January 8, 2020

ADDENDUM NUMBER THREE (3)

Project: Replacement Facility for
Tippah County Hospital
Ripley, MS
PN: 18015

FROM: Dean and Dean/Associates Architects, P.A.
4400 Old Canton Road, Suite 200
Jackson, MS 39211
(601) 939-7717

Sheet Number: G002

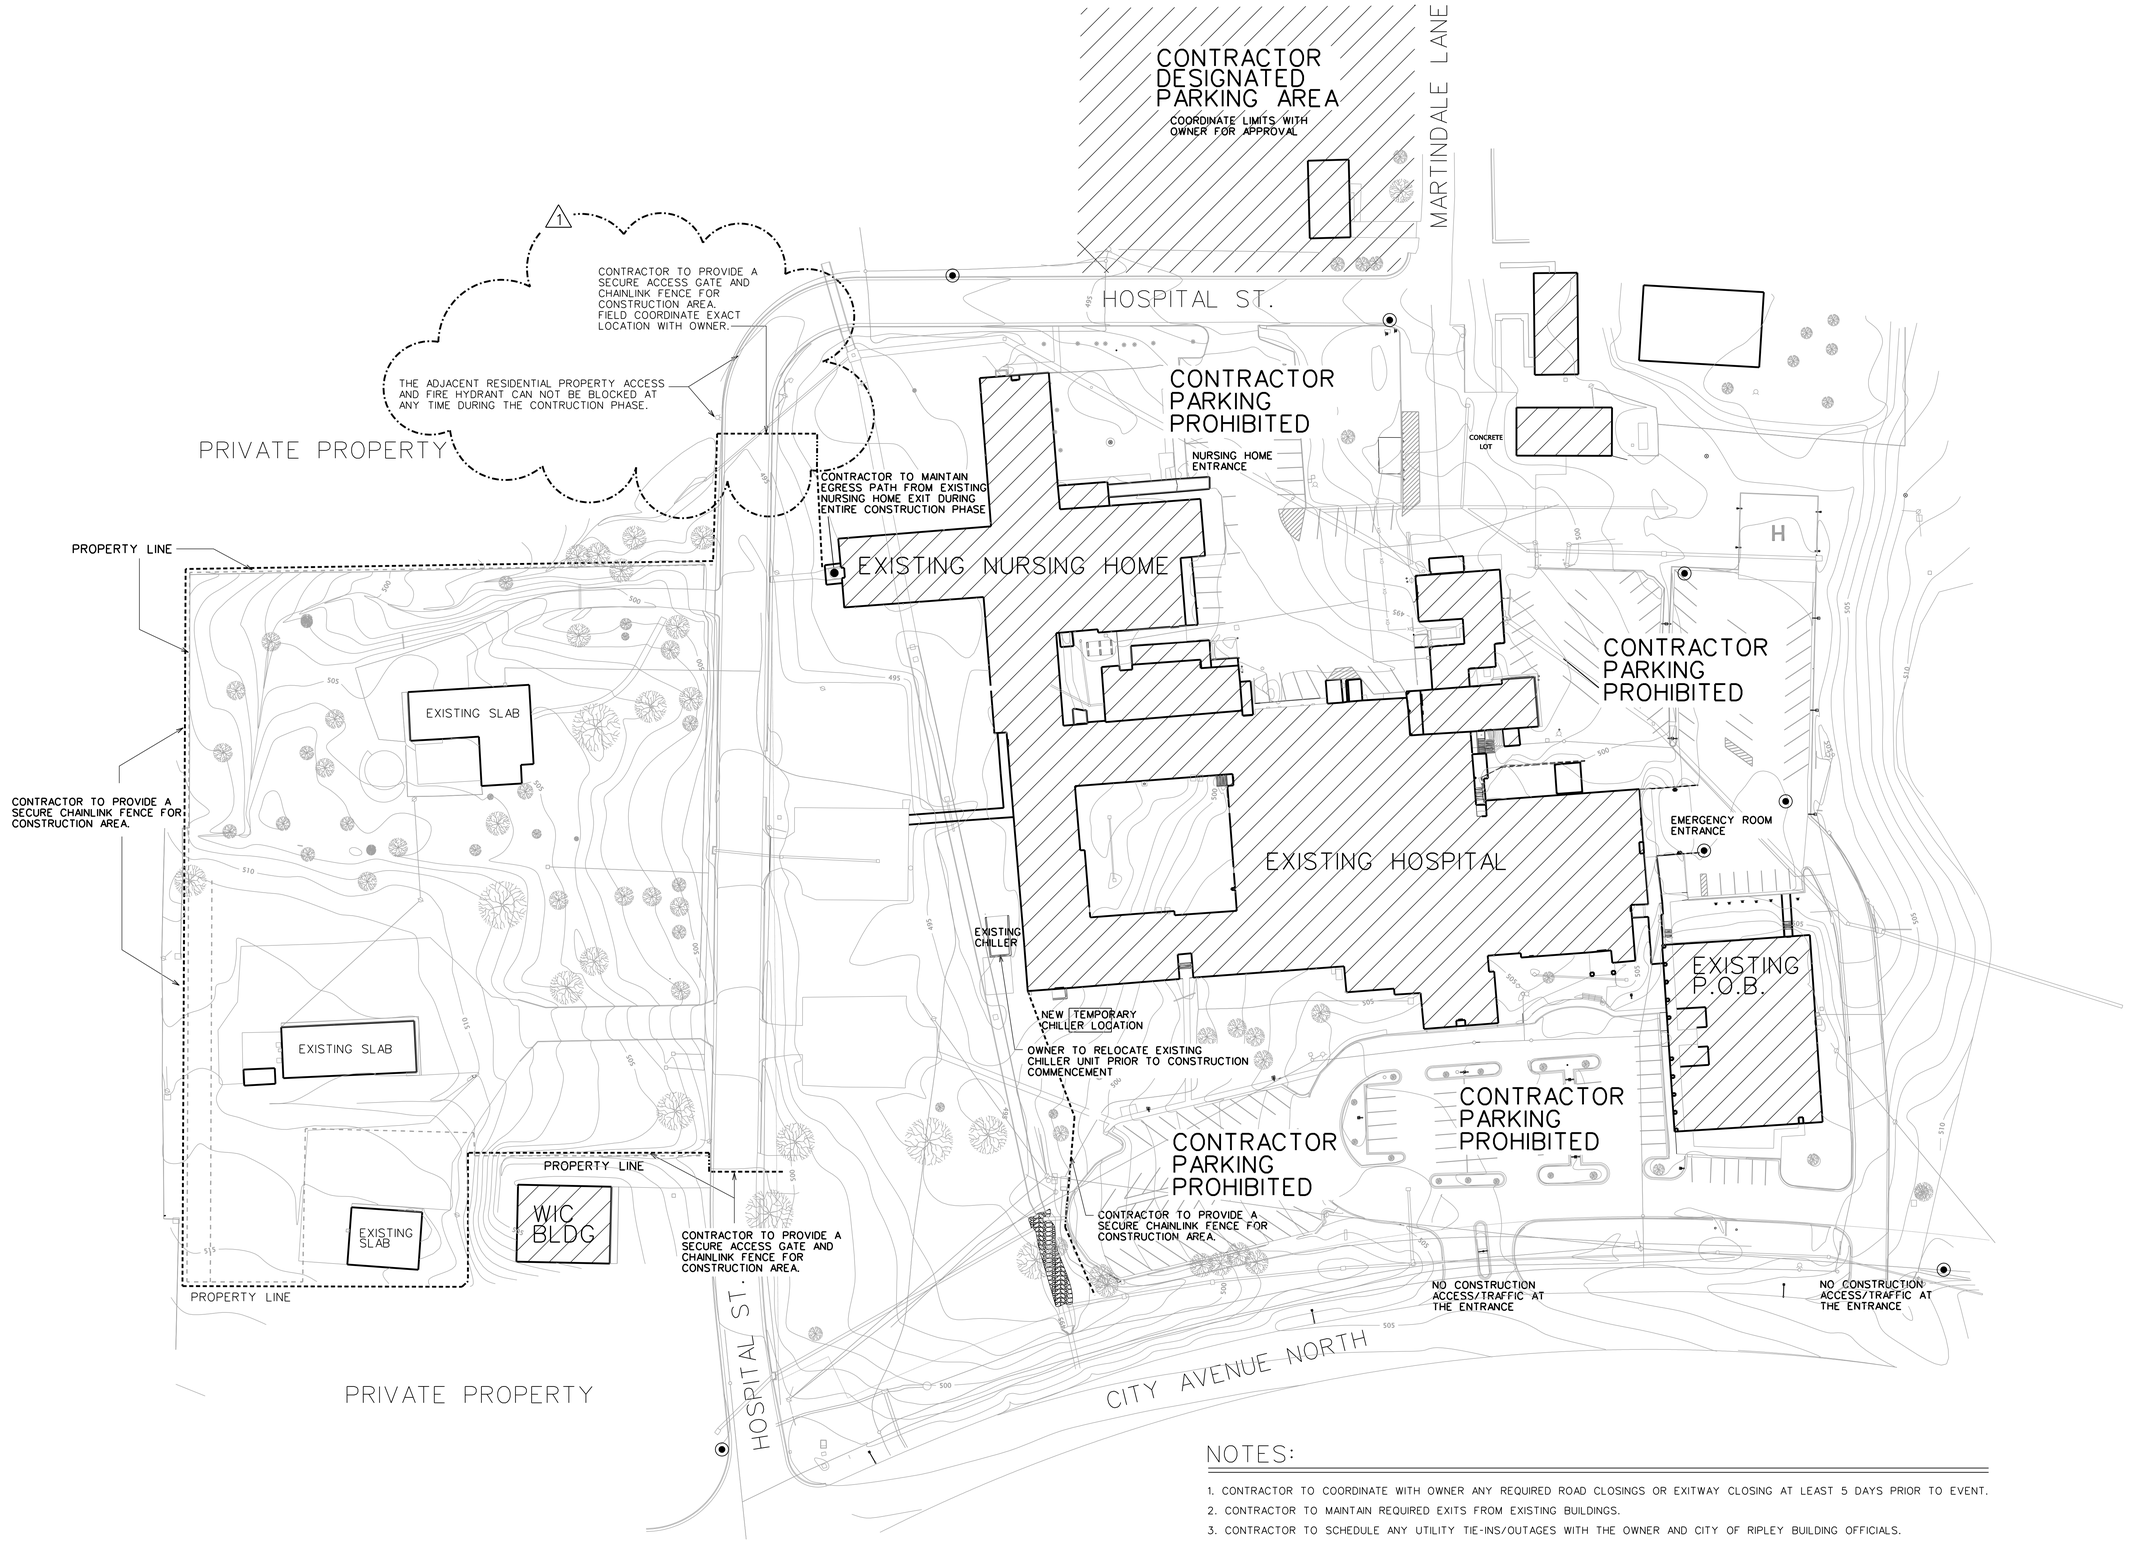
Replace this sheet in its entirety. NOTE: Clarifies location of secure gate.

Sheet Number : C5.2

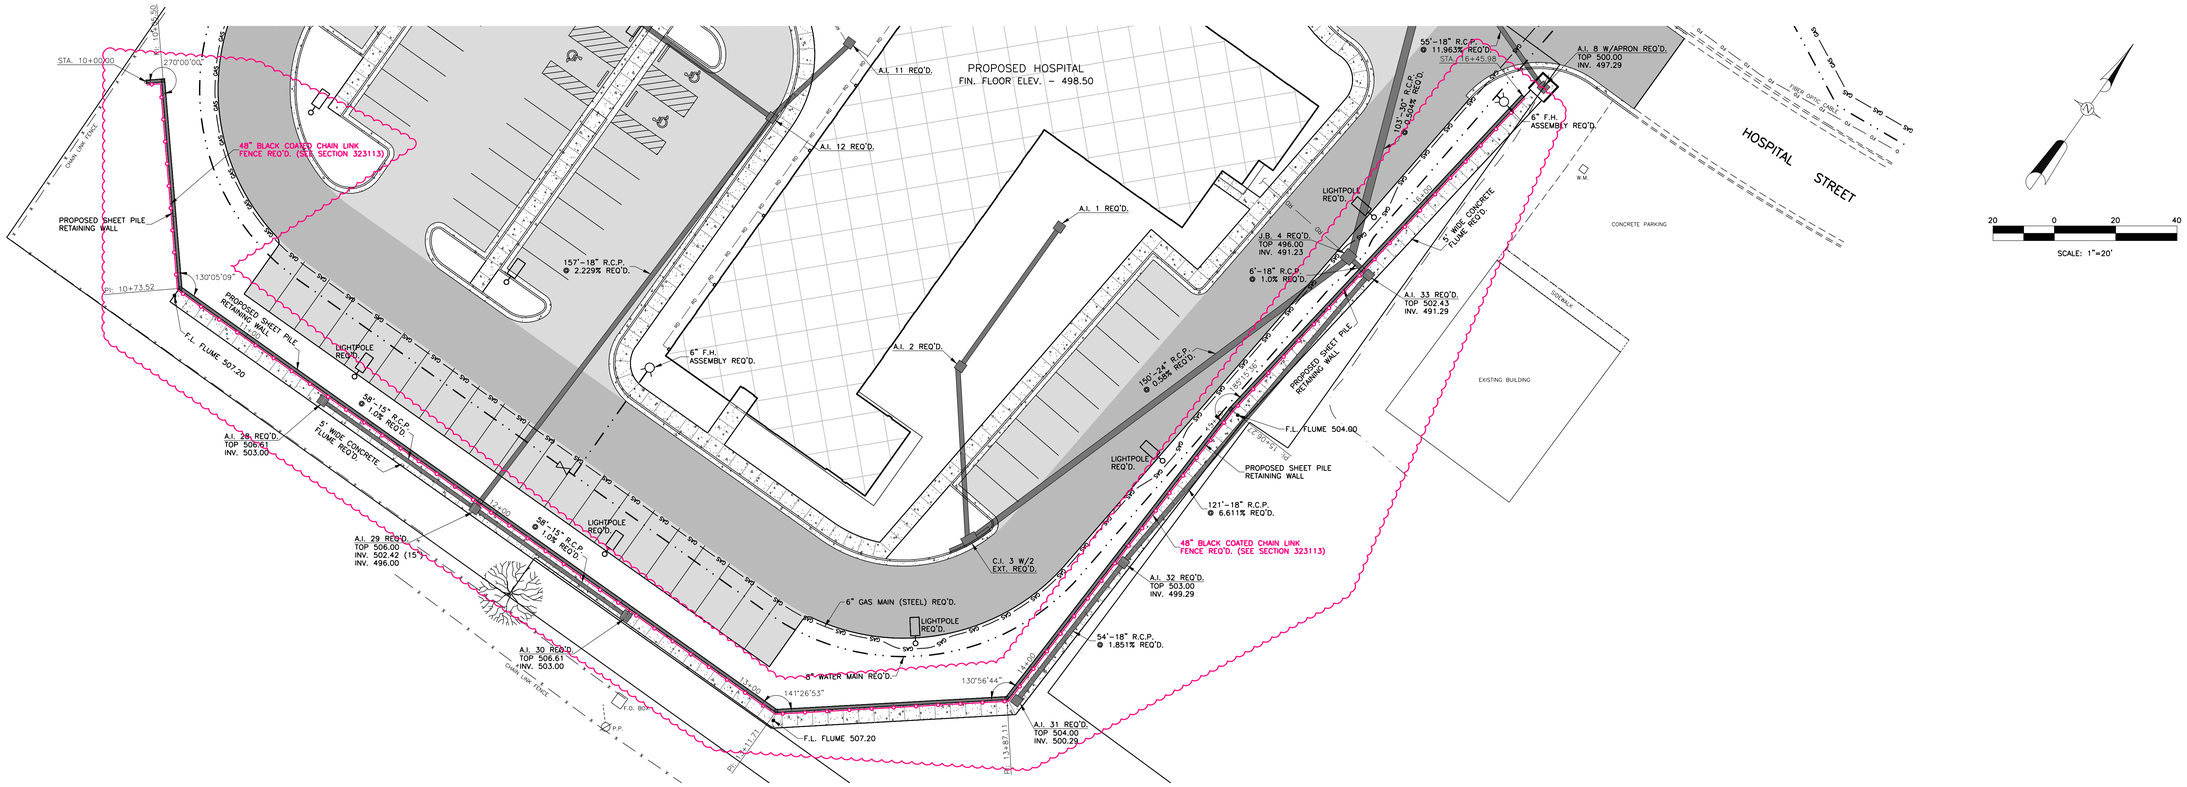
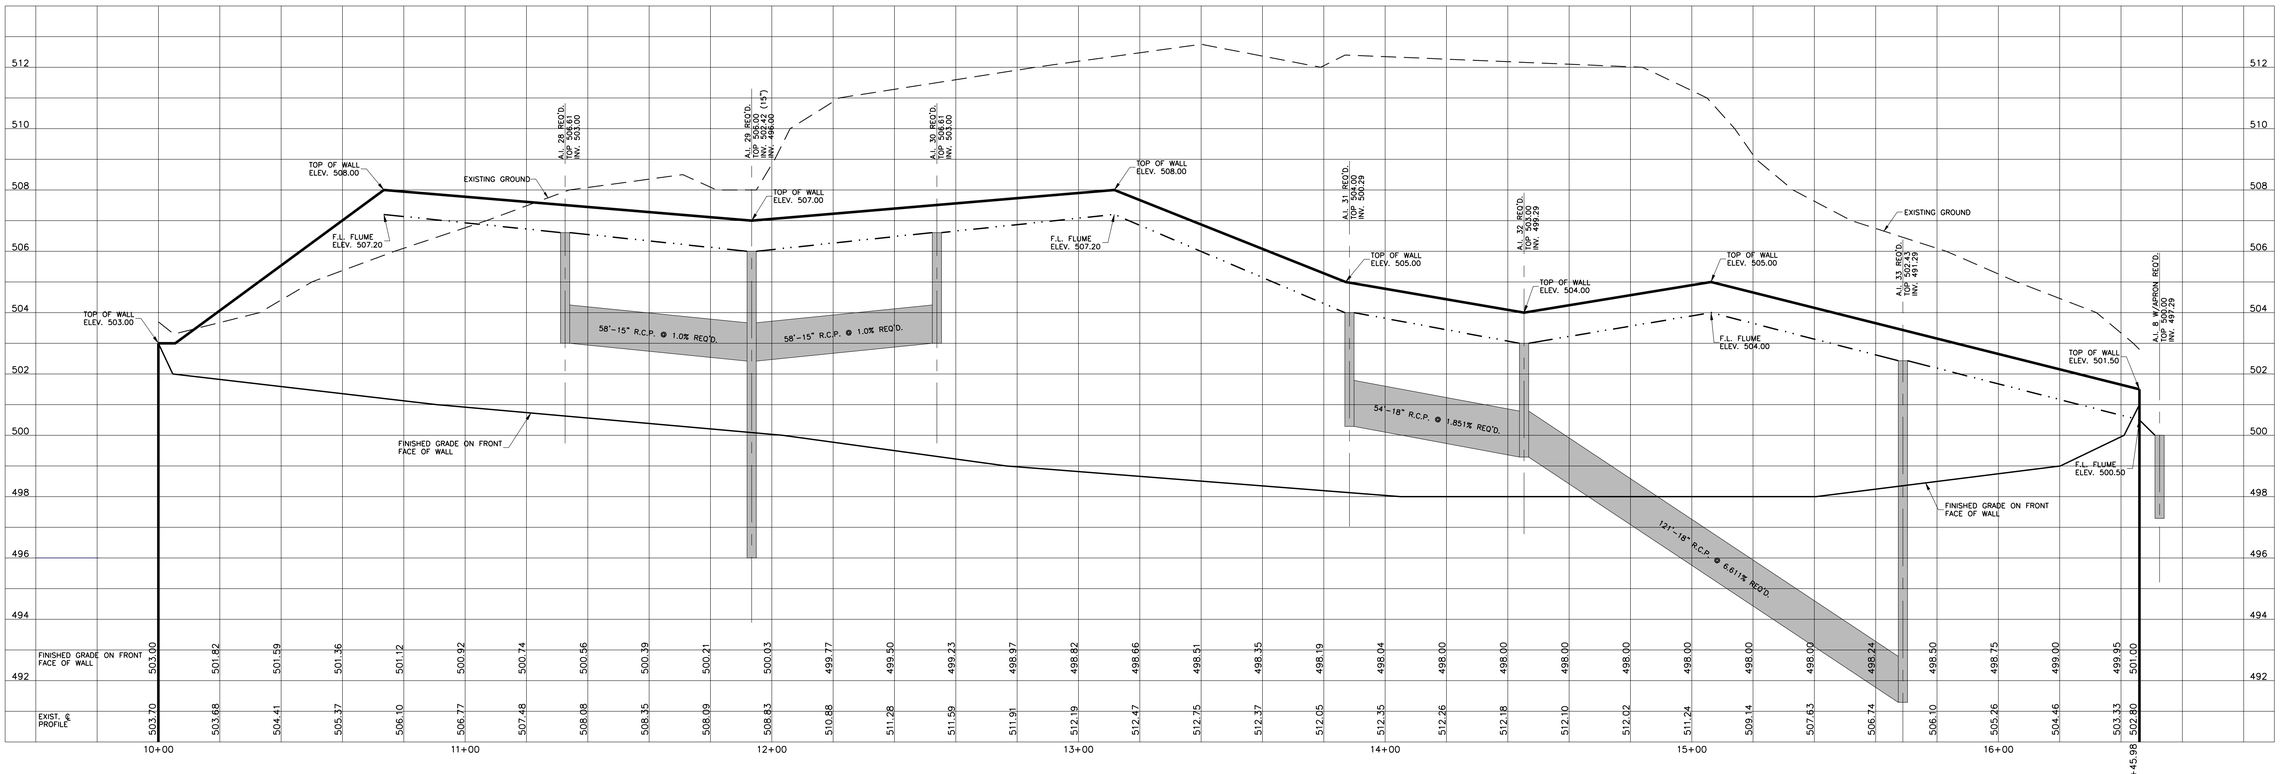
1.1 Item #1 - Enclosed is revised C5.2-'Plan & Profile – Retaining Wall' showing a 48" black coated chain link fence that is required.

Sheet Number : A402

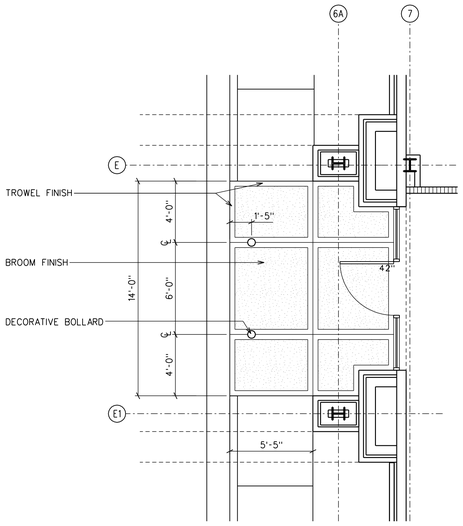
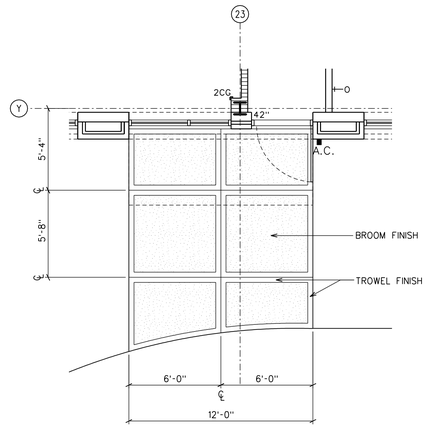
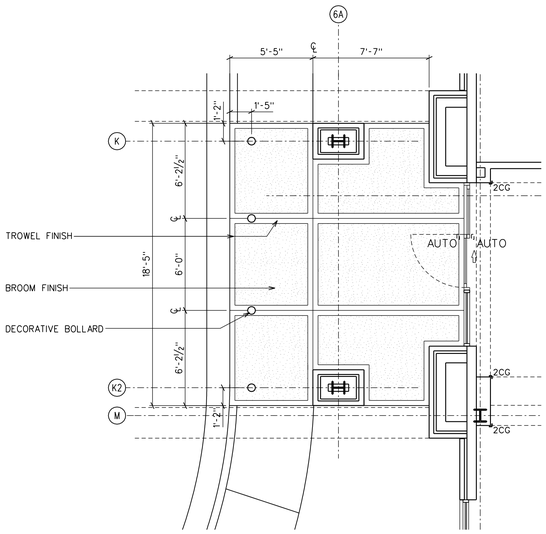
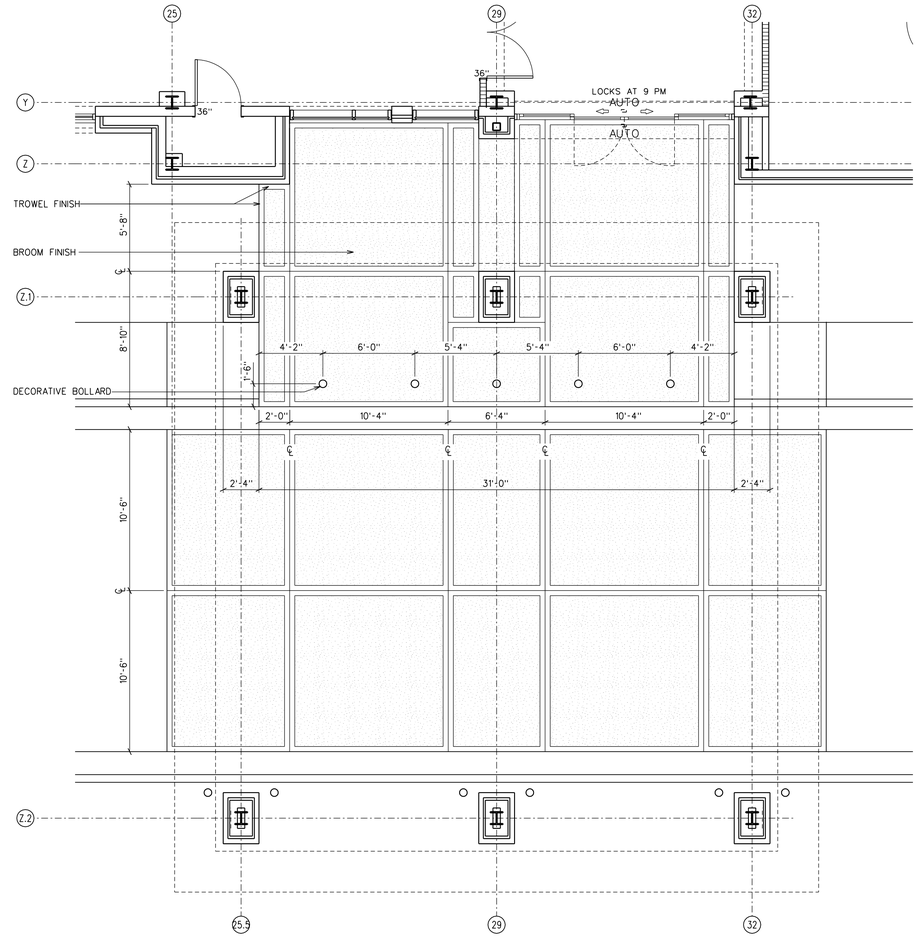
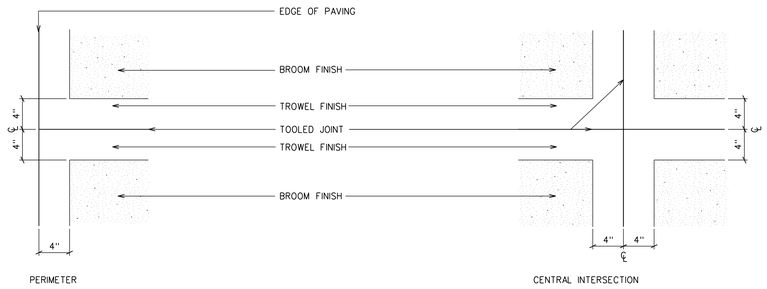
Item #6: Sheet A402 –Concrete Pattern At Entrances, as follows:

Sheet Number: P201.4

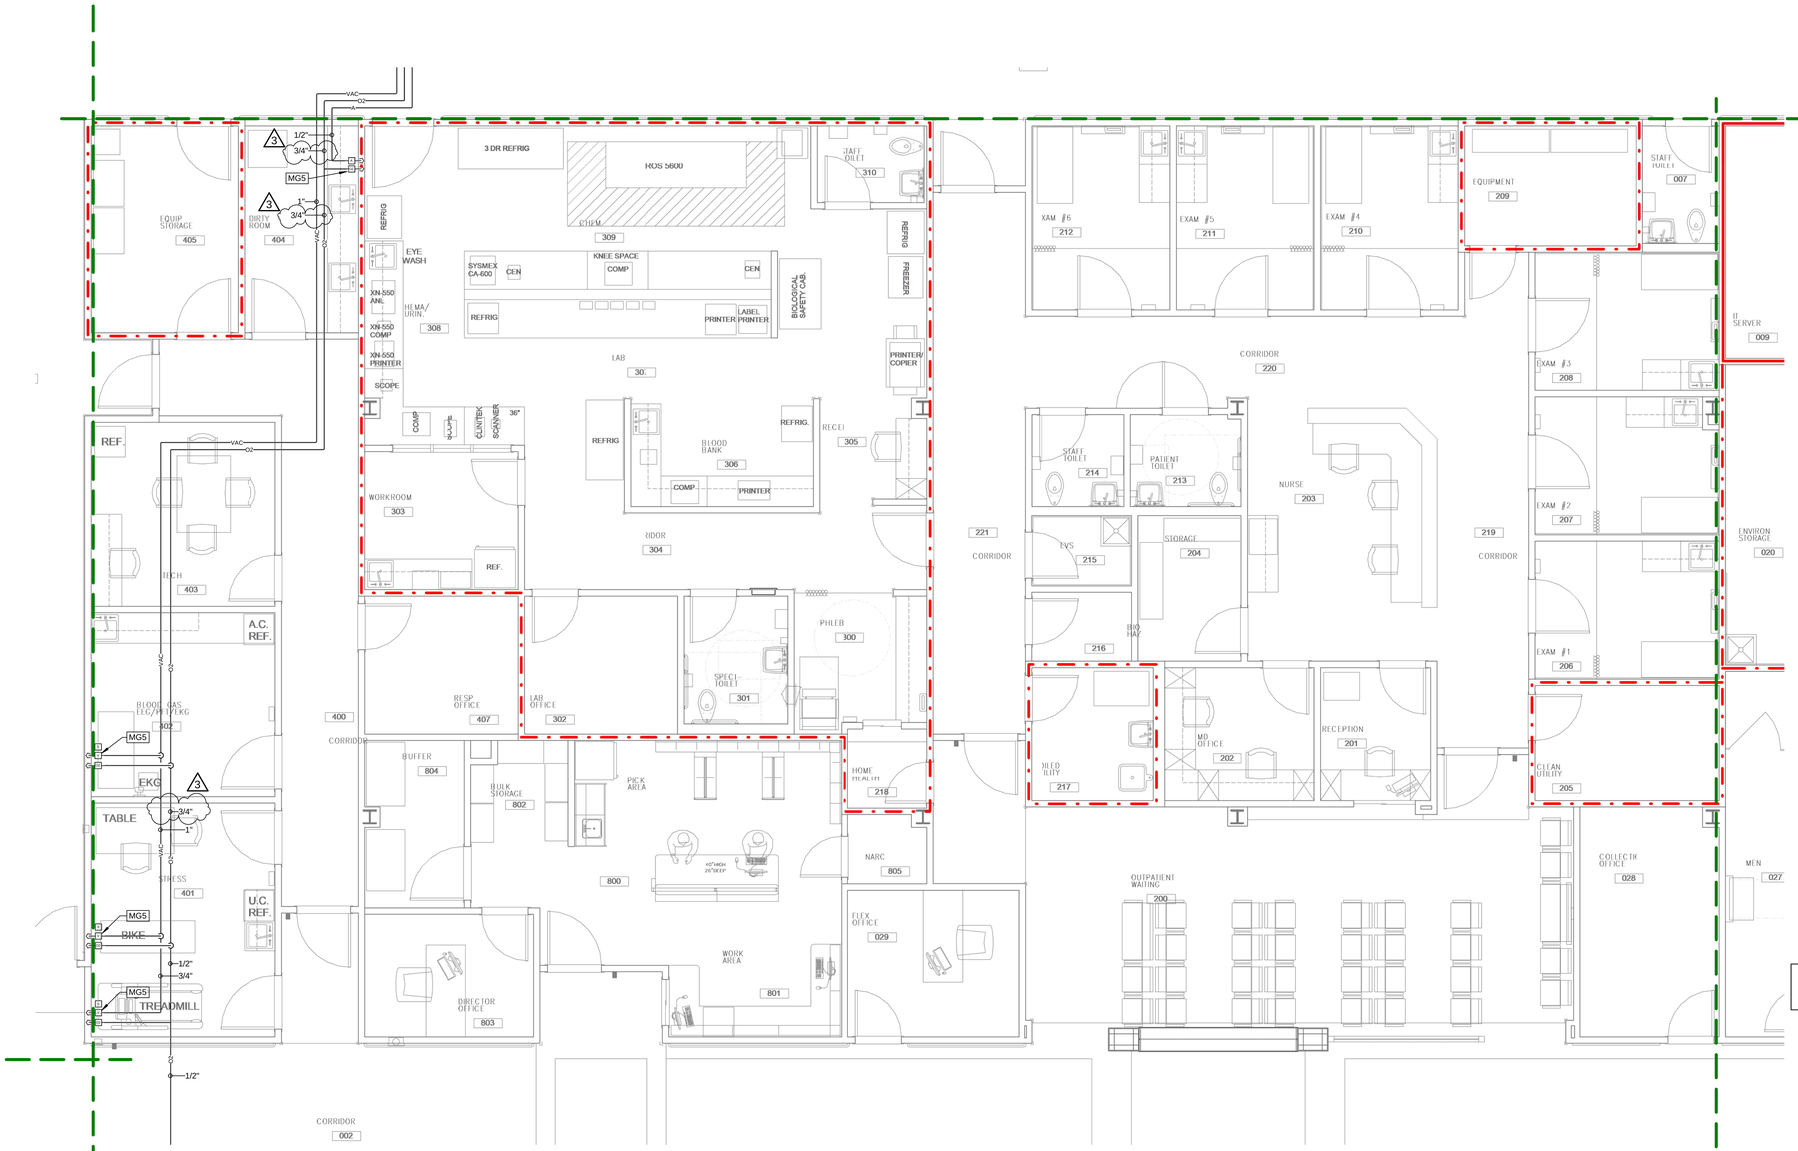
3. Sheet P201.4 – Enlarged Medical Gas Plan – Part "4". Delete sheet in its entirety and replace with revised sheet attached. Changed size of oxygen piping in rooms 401/404.
